City of Coconut Creek InterOffice Memorandum

To: Administrative Approval
File - PZ-07040016

Subject: **Technological University of
Miami
Coconut Creek Allstate Plat**

SITE PLAN STRIPING

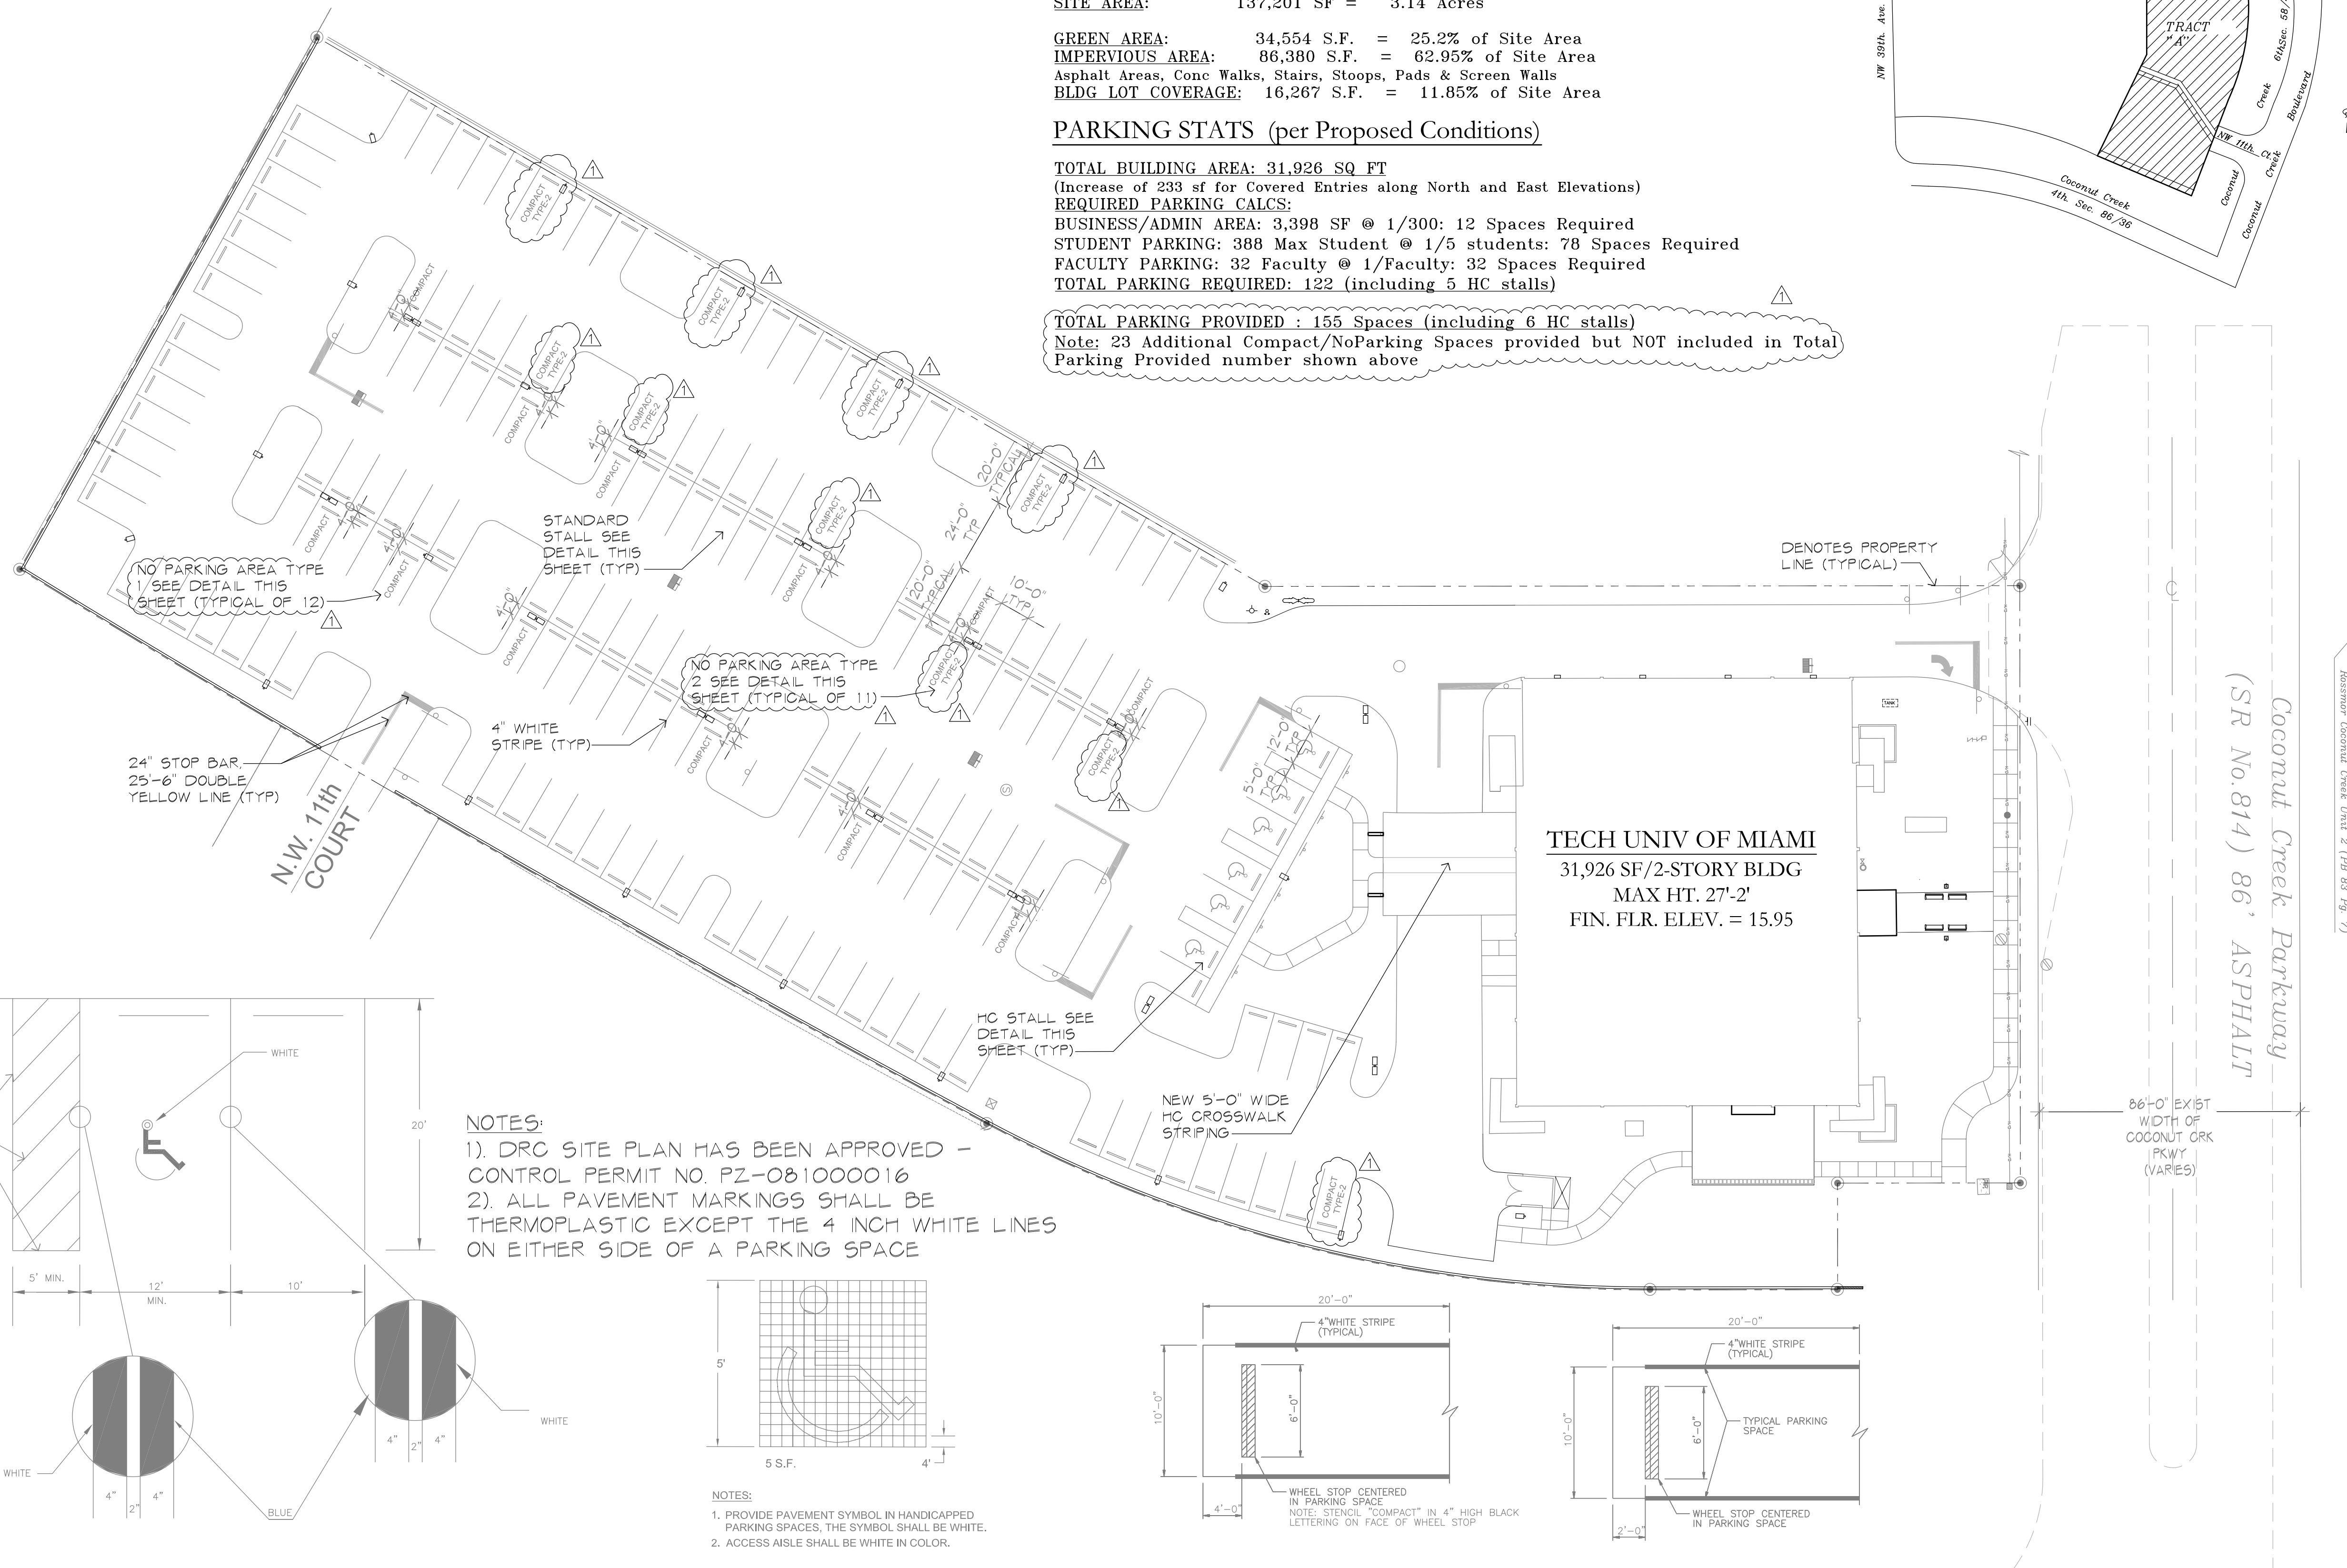
The applicant is requesting the allowance of surplus parking spaces be considered "compact" in nature for only those spaces where conflicts with light poles exist. City Code does not have design standards for compact parking. However, pursuant to Sec.13-395(47), additional spaces over the *required* number may be utilized to provide parking for similar use vehicles.

Therefore, it has been determined that minimum parking space requirements pursuant to the City's Land Development Code have been provided and additional parking exists. As requested by the applicant, surplus spaces may be designated for use by smaller vehicles. However, the applicant proposes to designate only twenty-three (23) spaces as compact leaving an additional ten (10) spaces consistent with minimum City Code design standards.

PLEASE FIND ATTACHED LETTER WITH PARKING CALCS AS REQUESTED. ALSO ATTACHED FOR YOUR RECORDS/REFERENCE IS THE REVISED SITE PLAN DEPICTING THE ADDITIONAL 11 STALLS THAT ARE NOT TO BE PARKED IN. PLEASE CALL IF YOU HAVE ANY QUESTIONS OR COMMENTS.

PURPOSE OF THIS LETTER IS TO CLARIFY THAT ALTHOUGH 23 OF THE TOTAL PARKING SPACES AT THIS PROPERTY ARE SUB-STANDARD PER CITY REQUIREMENTS AND SHALL NOT BE ALLOWED TO HAVE VEHICLES PARK IN THEM; THIS PROJECT STILL MEETS THE REQUIRED NUMBER OF STANDARD PARKING STALLS. BELOW IS A TABLE EXEMPLIFYING SUCH:

Note: 23 Additional Compact/NoParking Spaces provided but NOT included in Total Parking Provided number shown above
